AMENDMENTS TO THE DRAWINGS

Attached hereto are four (4) sheets of corrected formal drawings that comply with the provisions of 37 C.F.R. § 1.84. The corrected formal drawings incorporate the following drawing changes:

FIG. 5

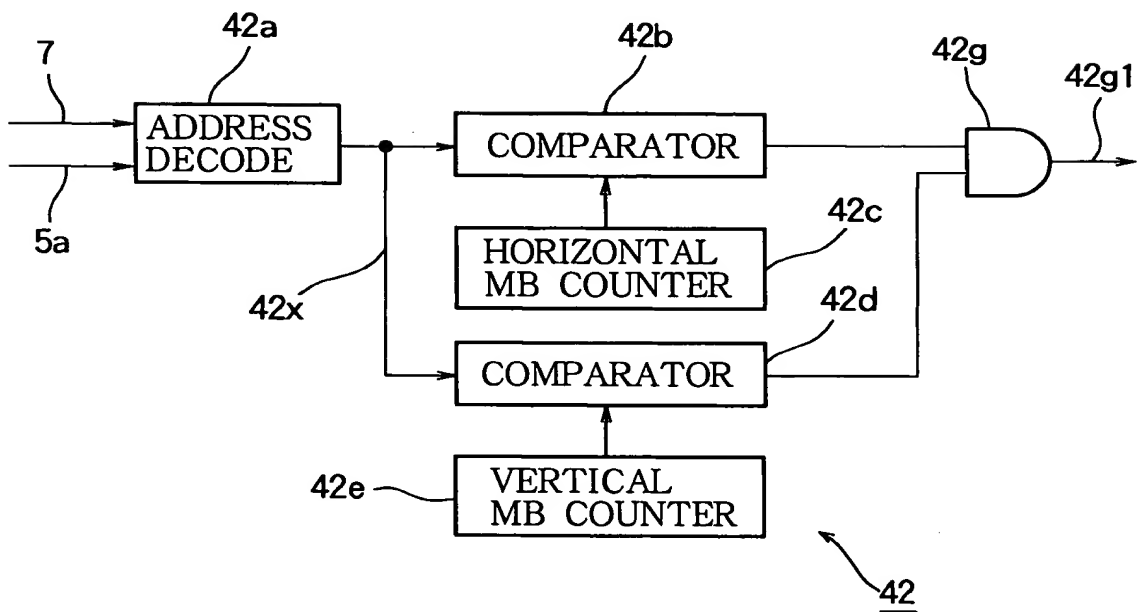
In addition, Fig. 5 has been corrected such that the logical circuit 42g is an AND circuit rather than an OR circuit such that this drawing is consistent with the second embodiment as discussed in the specification.

**FIG. 9**

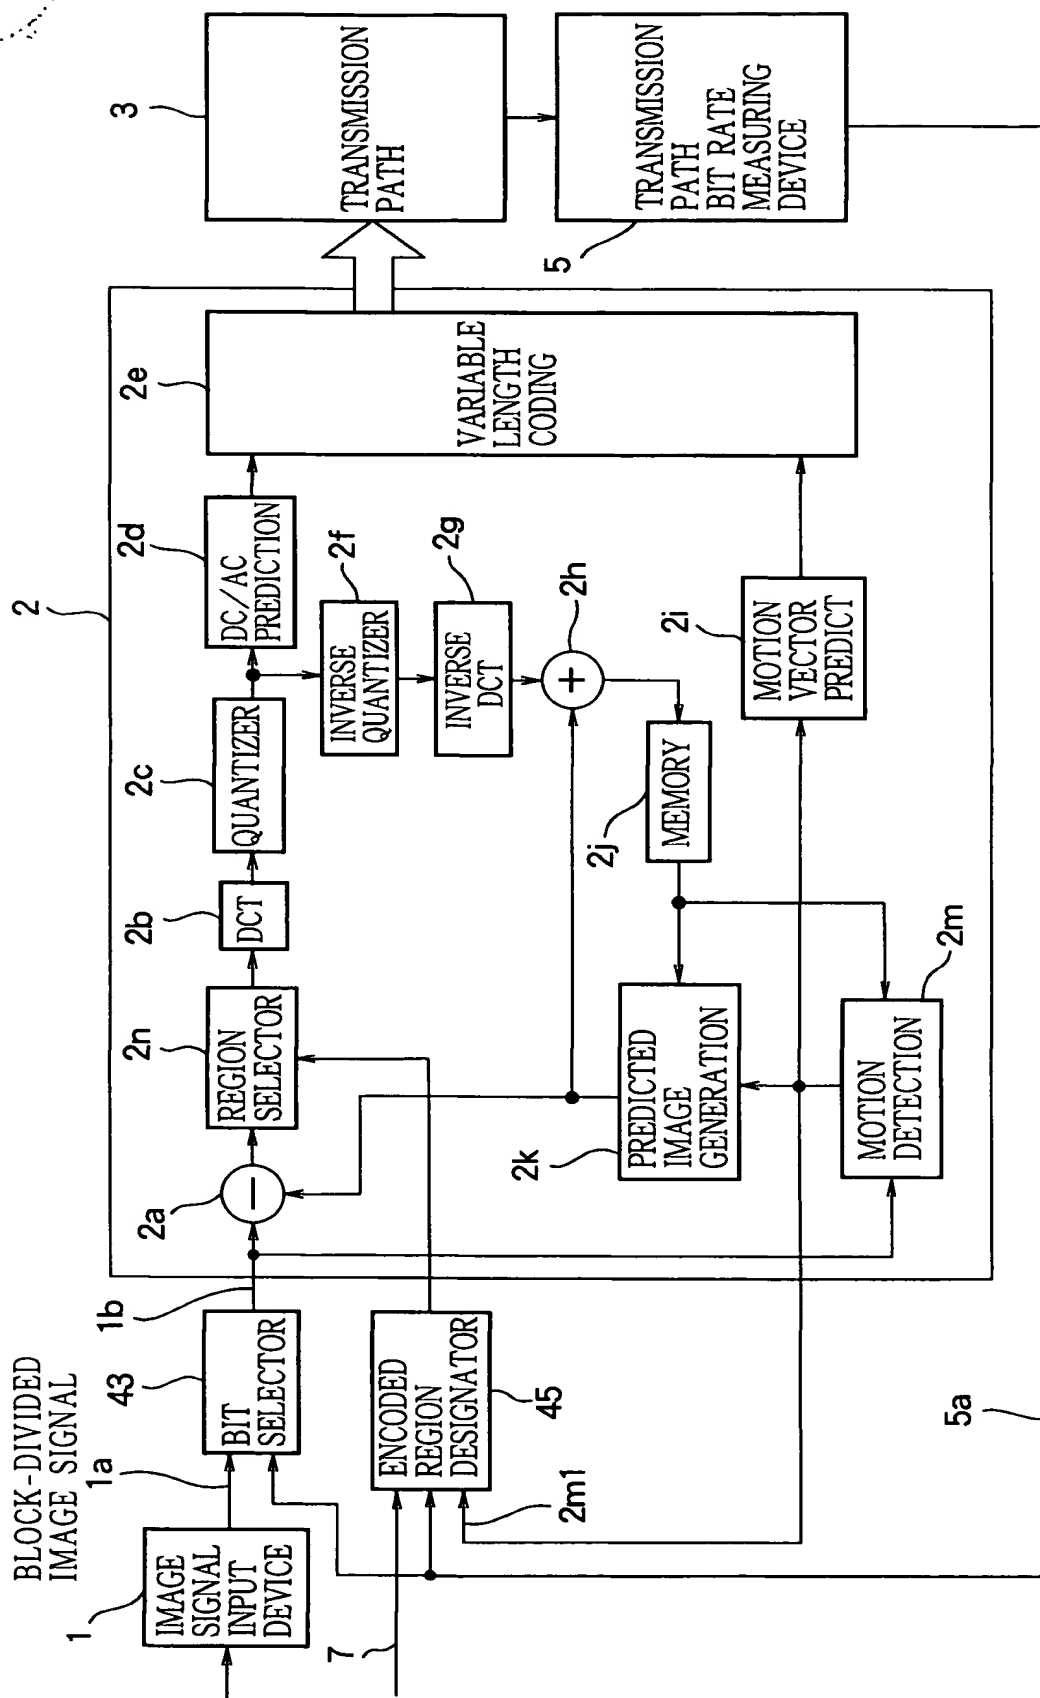
Fig. 9 has been corrected as outlined by the helpful suggestion by the Examiner. Even more specifically, the Encoded Region Designator 45 is now connected to the Region Selector block 2n instead of DCT 2b.

**FIG. 12**  
**PRIOR ART**

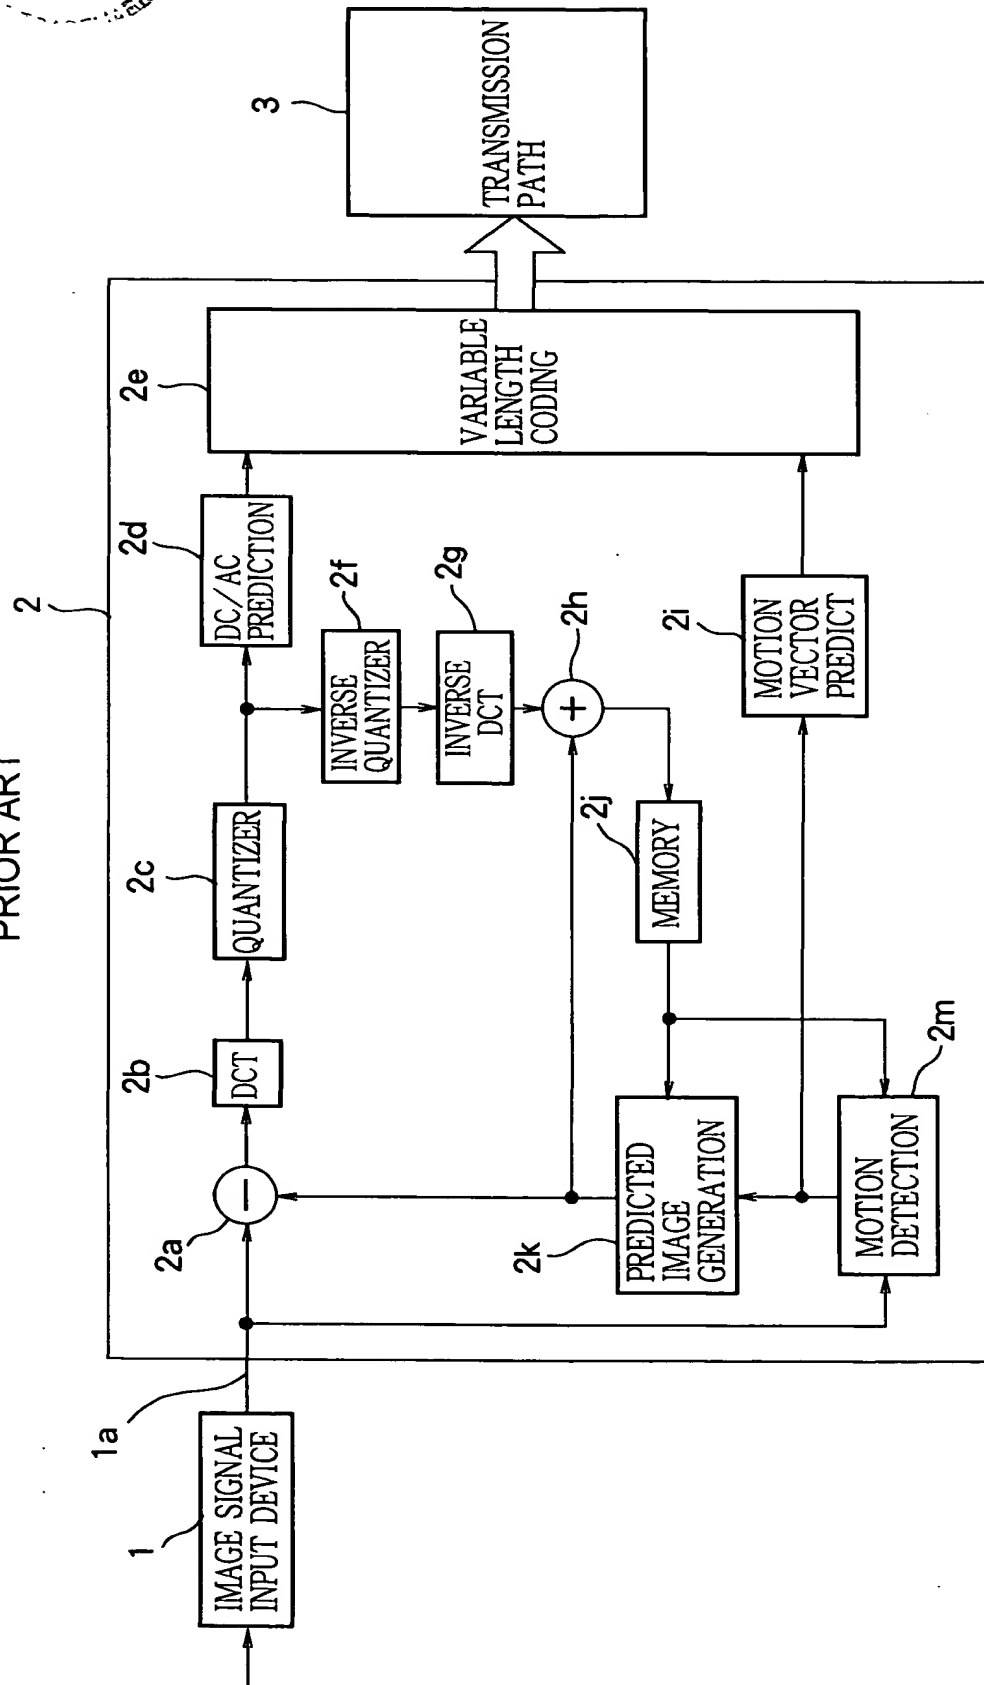
Furthermore, Figs. 12 and 13 have been designated by the label "Conventional Art" as these figures merely illustrate background or conventional art.
